Technical Service Information

THM 4T80-E NEW DESIGN SHIFT SOLENOIDS

Figure 1

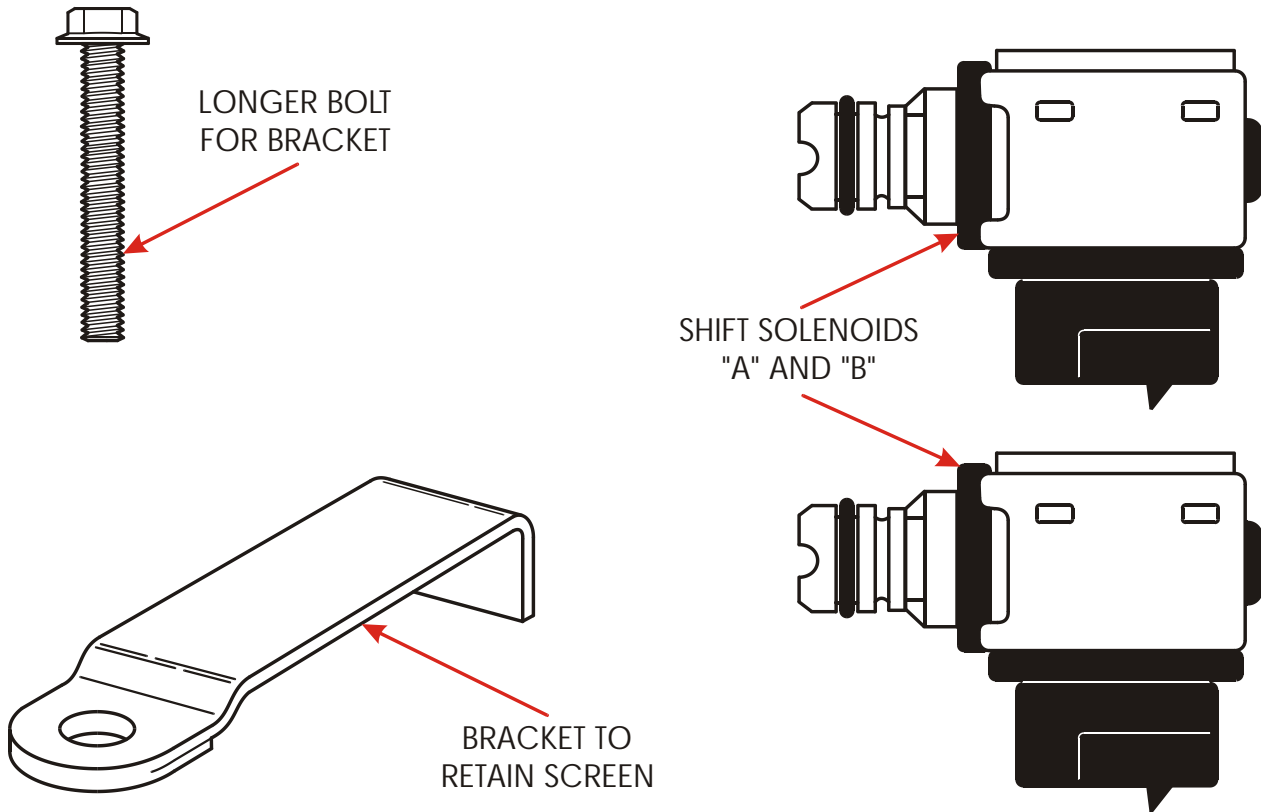
- (1) SHIFT SOLENOID "A" AND "B" - Now manufactured without the "Tab" on the solenoid, as shown in Figures 2 and 3.
- (2) SOLENOID SCREEN BRACKET - Additional bracket added to retain the Shift Solenoid Screen in the valve body, as shown in Figure 3.
- (3) BRACKET BOLT - Longer bolt also included in service package part number 24211355 to accommodate the added bracket, as shown in Figure 1.

Shift Solenoid "A" (2nd Design)	24207662
Shift Solenoid "B" (2nd Design)	24207662
Service Package (To Service 1st Design Level)	24211355
Solenoid Filter Retaining Bracket	24205848
Solenoid Filter Retaining Bracket Bolt	8680869
Solenoid Filter	8680389

Figure 2

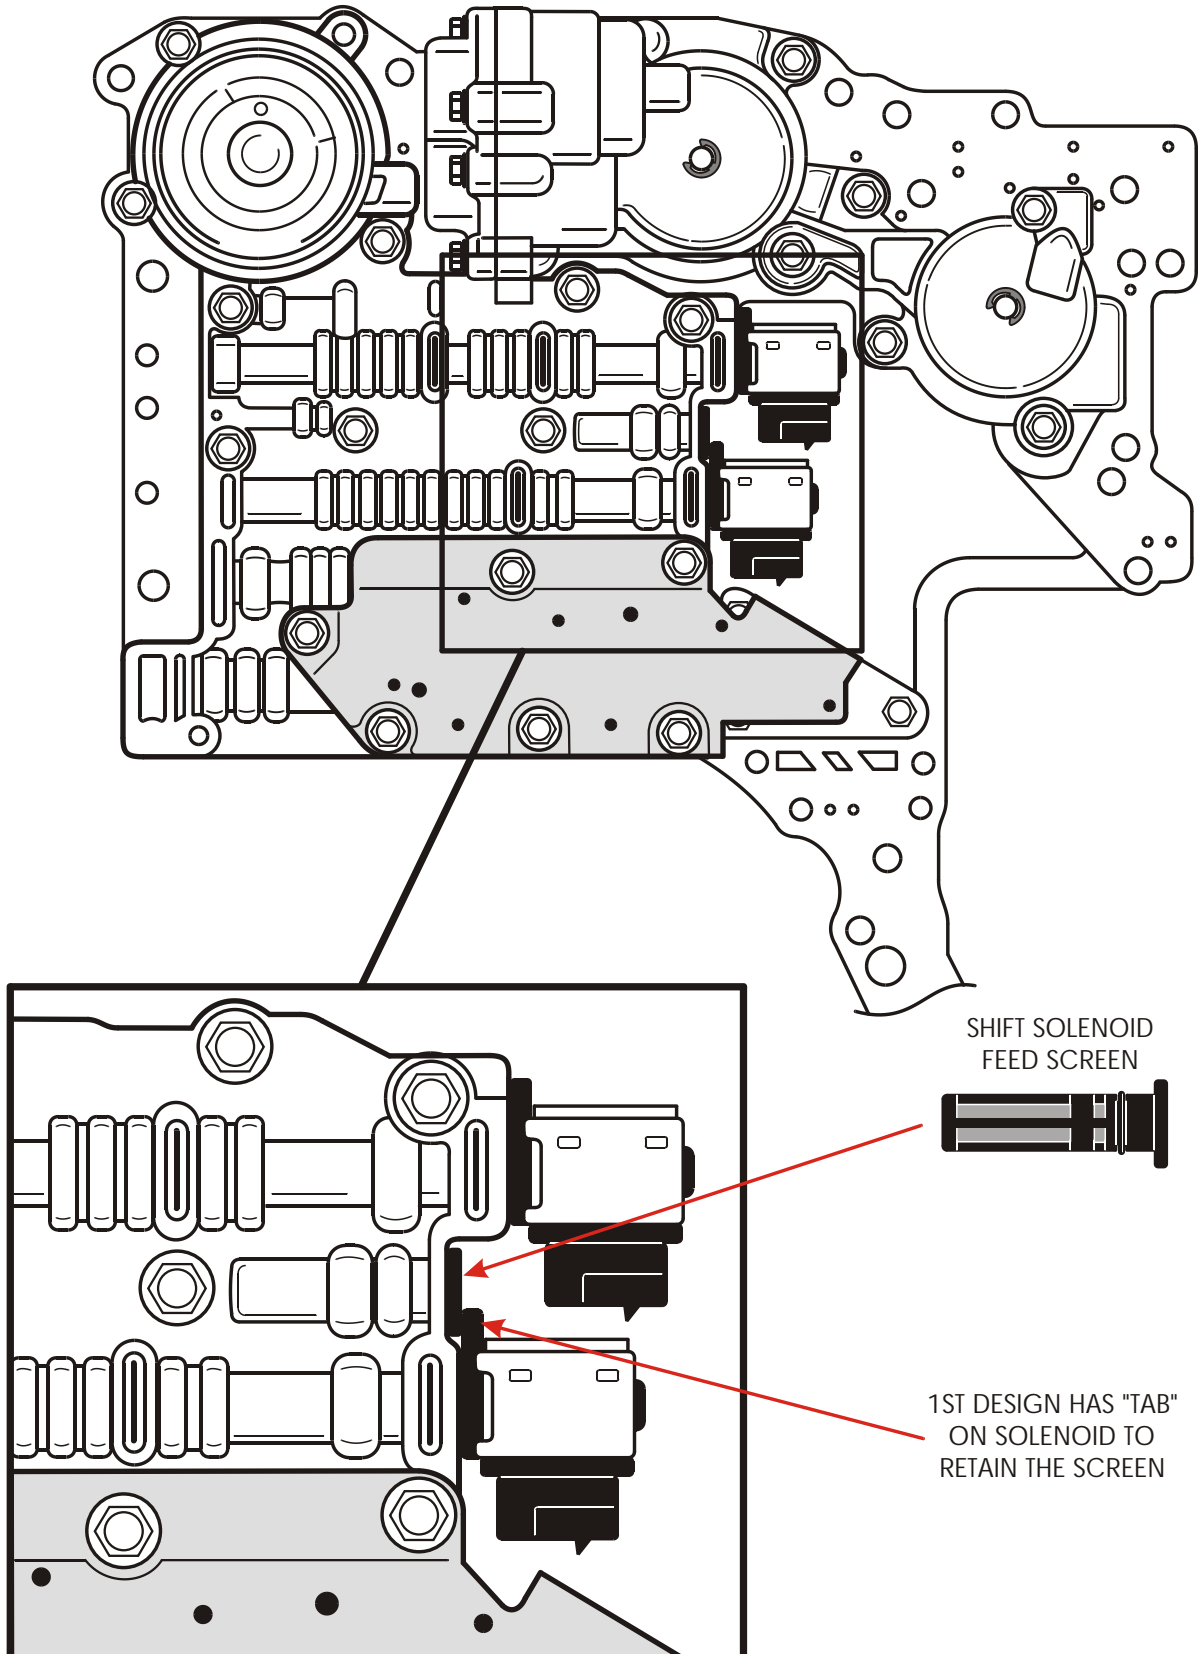
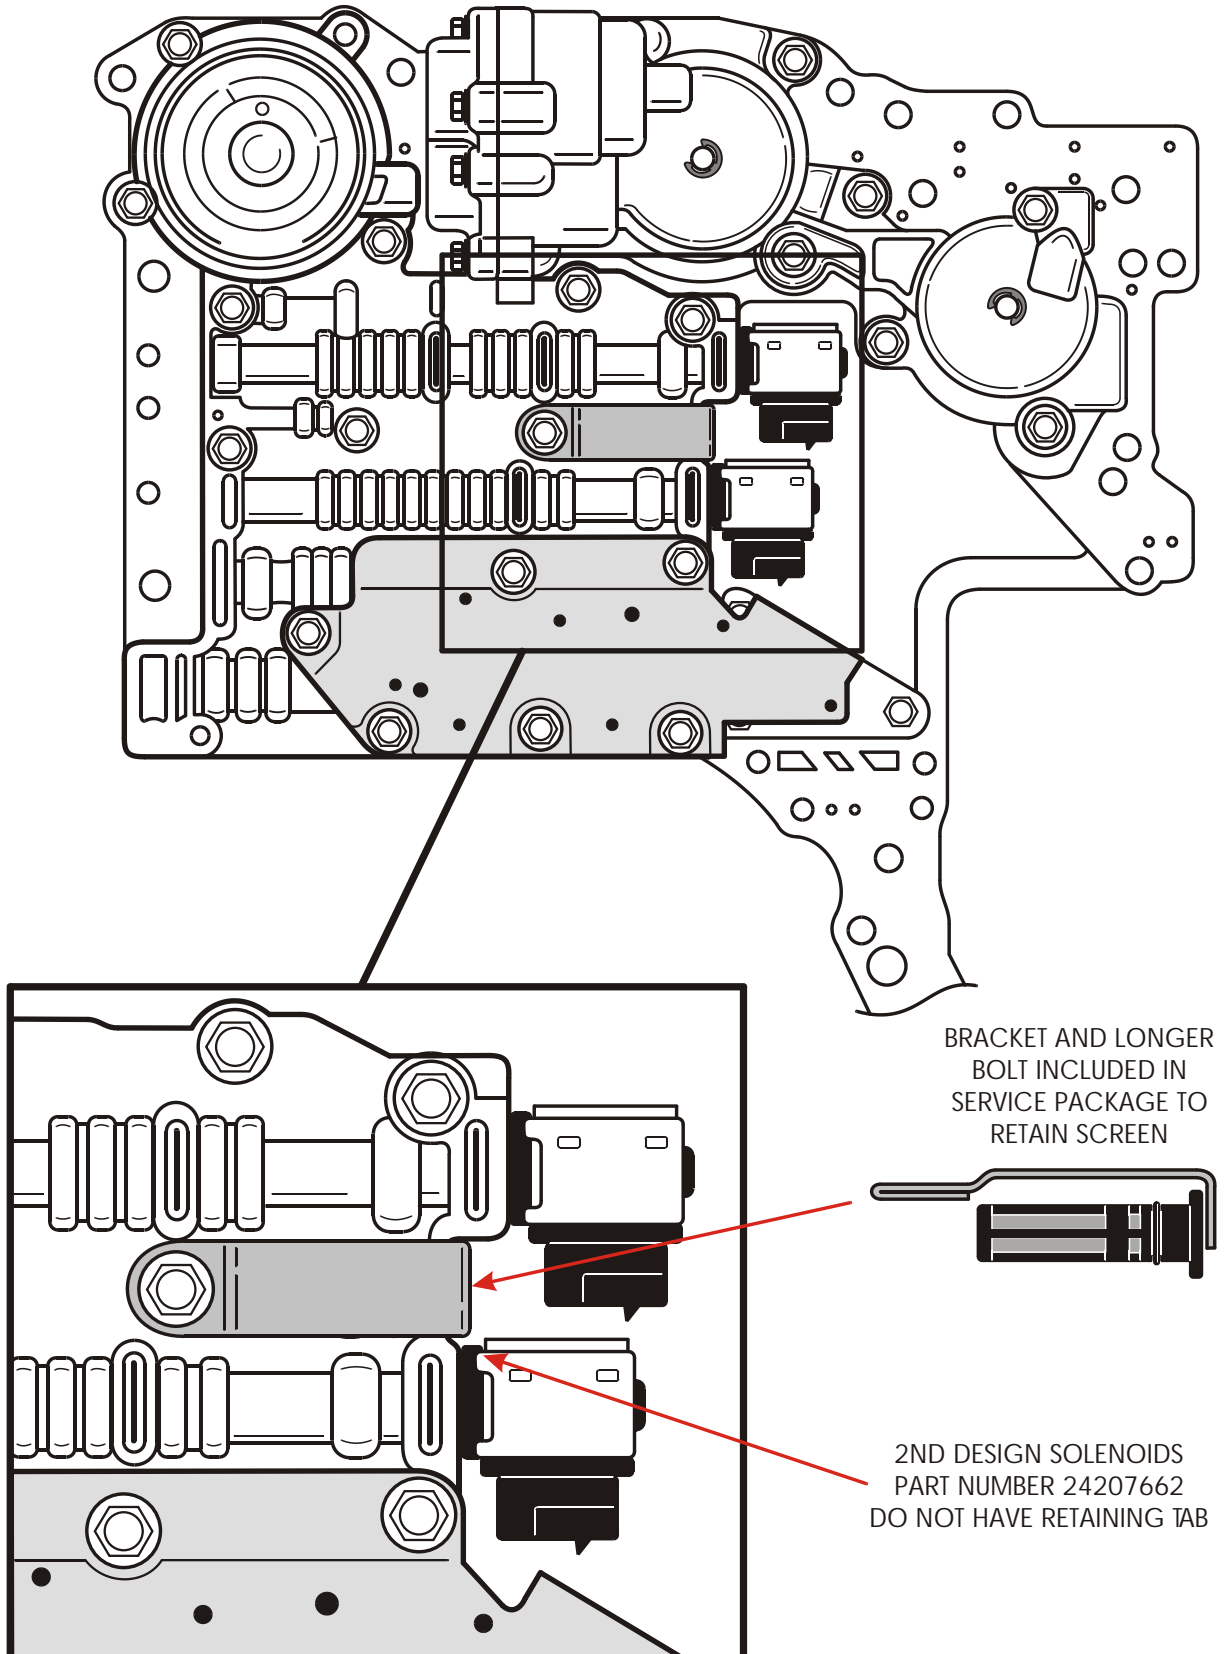
CHANGE: All vehicles equipped with the THM 4T80-E transaxle are now being built with a new design level of Shift Solenoids. Shift Solenoid "A" and Shift Solenoid "B" previously had a "Tab" incorporated on the solenoid to retain the Shift Solenoid Feed Screen in the valve body, as shown in Figure 2. The Shift Solenoids are now manufactured without the "Tab" on the solenoid, and an additional bracket is used to retain the screen in the valve body, as shown in Figure 3. Previously General Motors has not serviced the Shift Solenoids, except on a complete valve body. The Shift Solenoids are now a service item from General Motors available under OEM part number 24207662 for the 2nd design solenoids only. There is also available under OEM part number 24211355, a service package that includes two 2nd design Shift Solenoids, a new bracket to retain the screen and a longer bolt for the new bracket, as shown in Figure 1.

REASON: Constant actuator feed oil pressure on the solenoid screen pushing on the "Tab" on the first design shift solenoids, would break the shift solenoid plastic neck. The new design Shift Solenoids will greatly increase durability of the solenoid.

If you are servicing one of the previous design vehicles with the "Tab" on the Shift Solenoids, you must purchase service package part number 24211355, as the 1st design solenoids are not available. If you are servicing one of the 2nd design vehicles, you can now order just the Shift Solenoids "A" and "B" under Oem part number 24207662.
